Access Compliance Report

Public Rights-of-Way

(Curb Ramps)

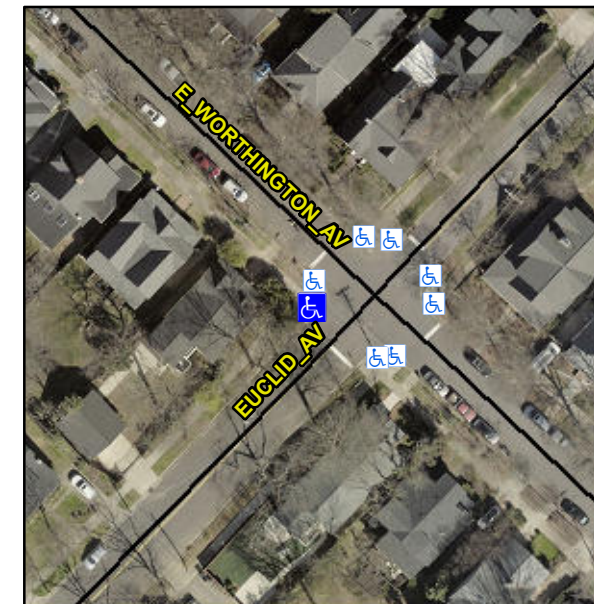
Intersection ID: 14378	Main Street: E_WORTHINGTON_AV	Cross Street: EUCLID_AV	Location: W
ADA ID: 17BBD0C6CF70	Ramp Type: Directional1	Initial Pass/Fail: Fail	Overall Compliance: No
Codes/Mitigation Info/Possible Solution		Field Measurements/Component Compliance	
Severity Score: 1.25

R304.5.3

Remove & Replace Entire Ramp.
